Re: Variance Application

Forest Glen – Lots 292-295 8034 Forest Glen Drive Pasadena, Maryland 21122

VARIANCE SITE PLAN

CONFIRMATION OF PRE-FILE

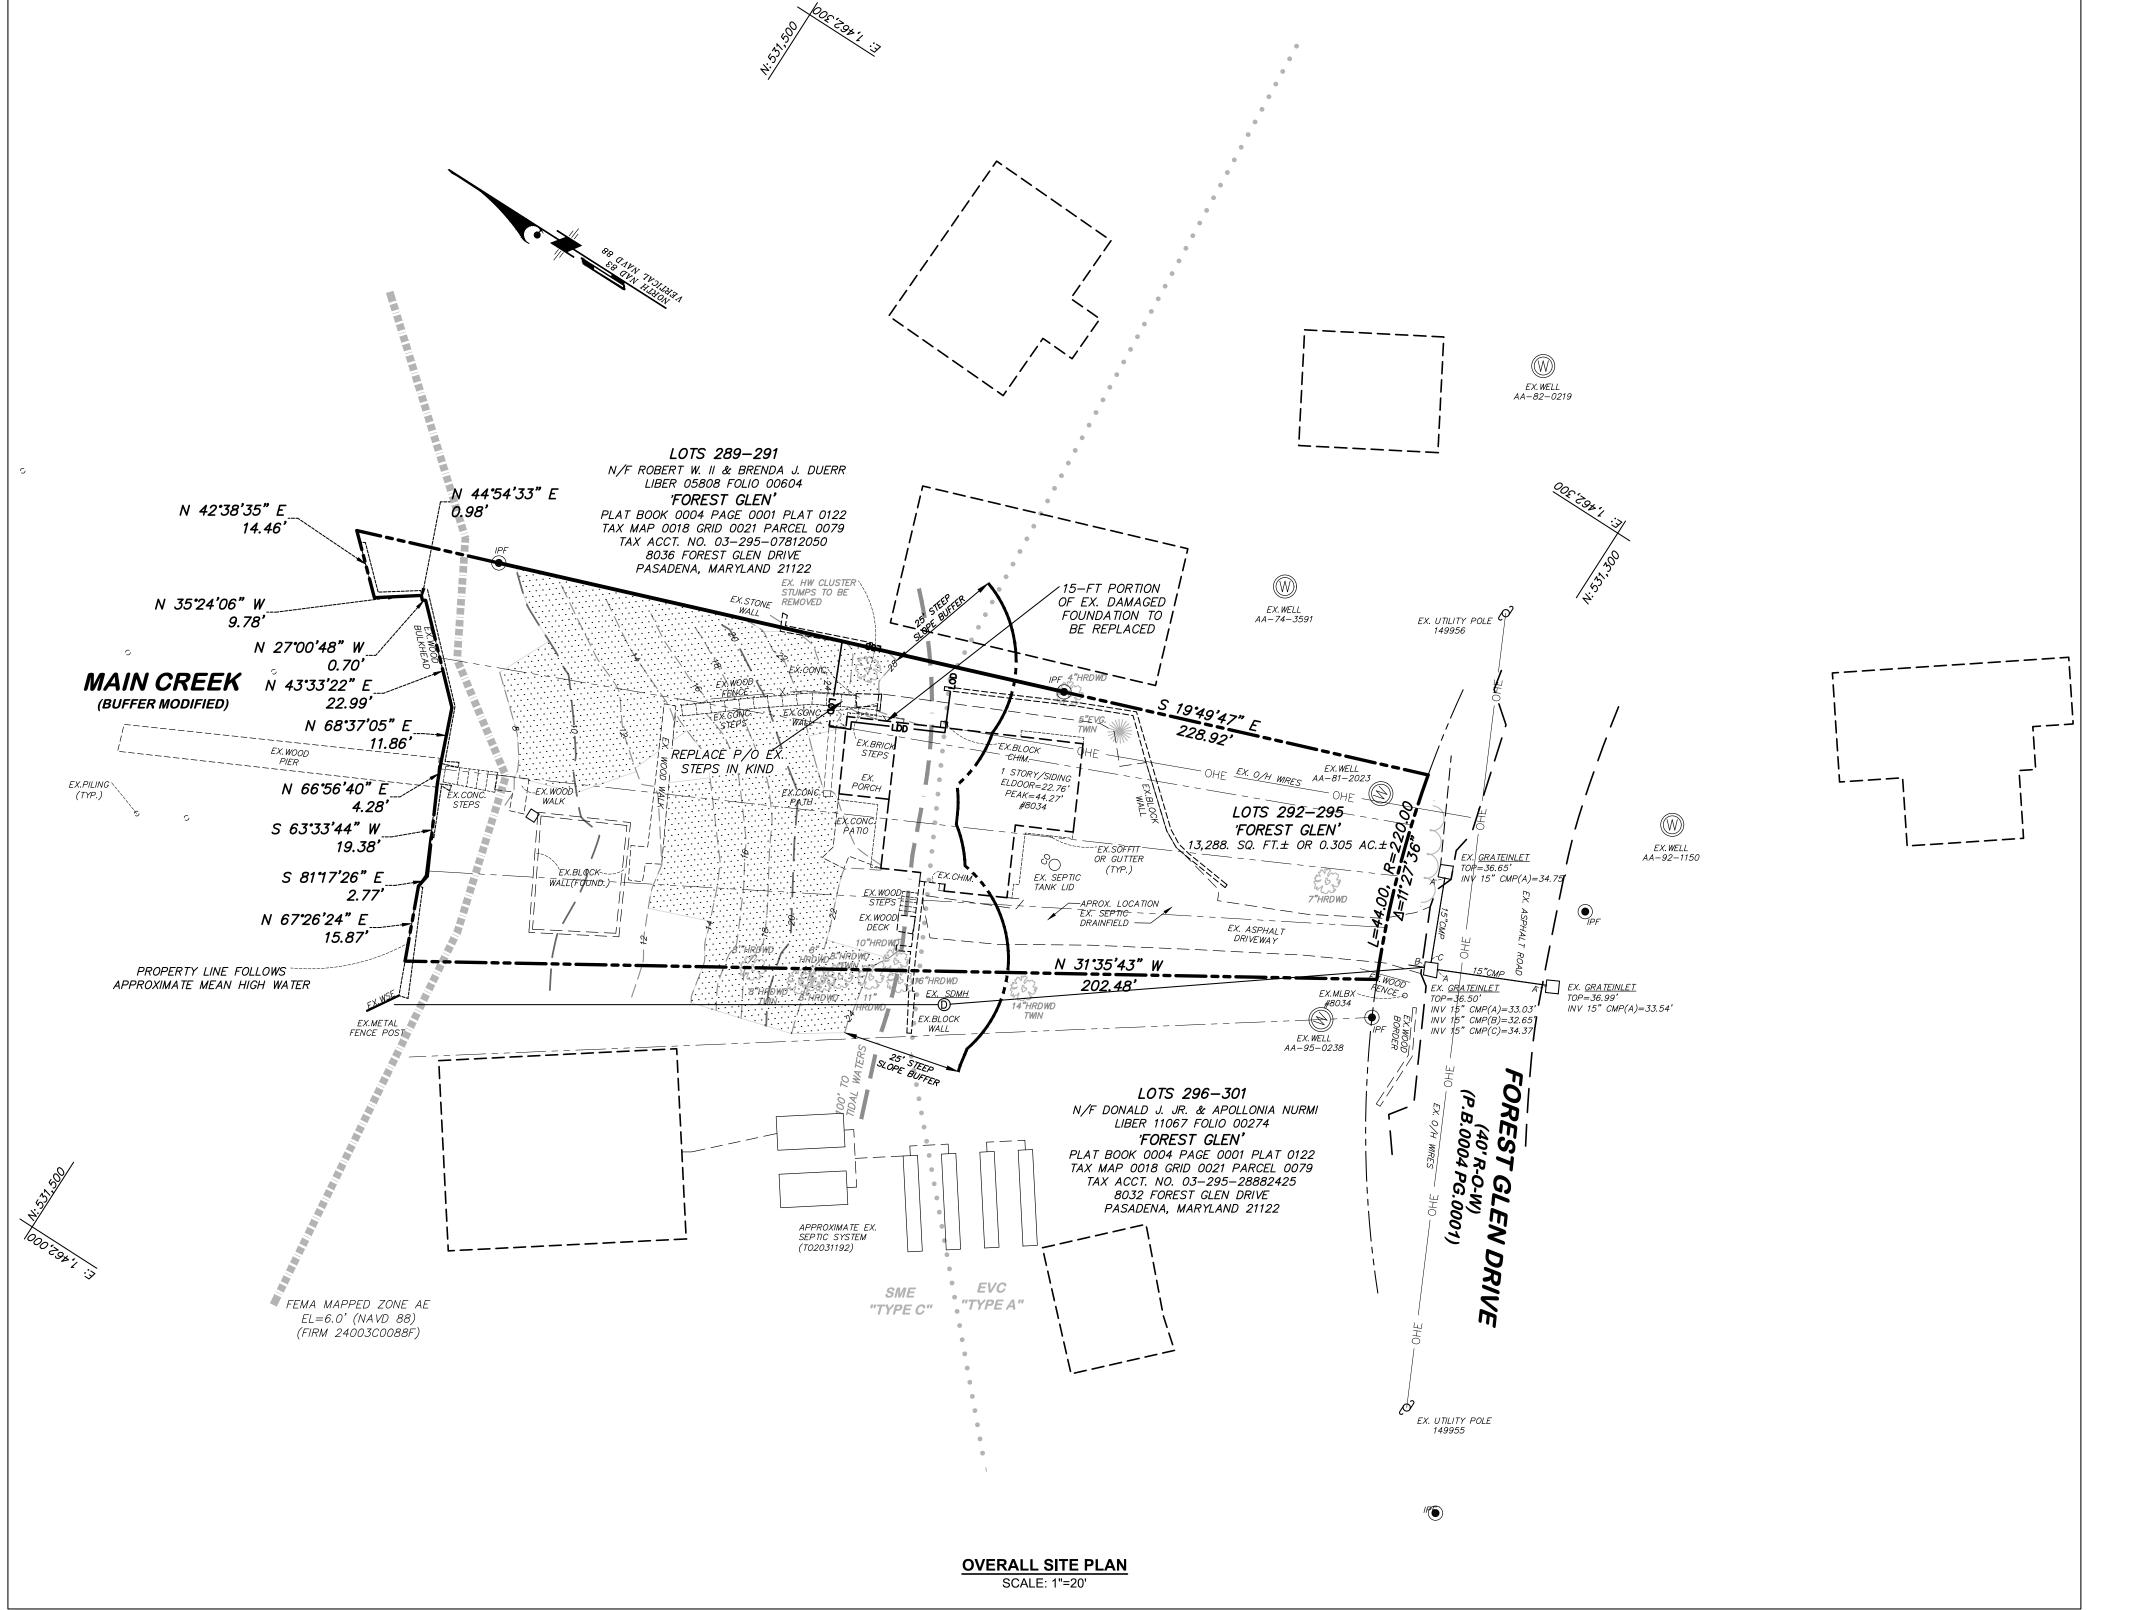
Site plan: note that the zoning setback for the rear is 25', not 27' as shown on the site plan

A pre-file review by the Office of Planning and Zoning was issued on July 8, 2024, the Confirmation of Pre-file comments are enclosed for review. The Critical Area Team had no objection and Zoning confirmed the requested variance is required and that the zoning setback noted for the rear needed to be corrected. Subsequent to the pre-file, the plan has been updated to correct the rear setback noted, no other changes have been made to the plan.
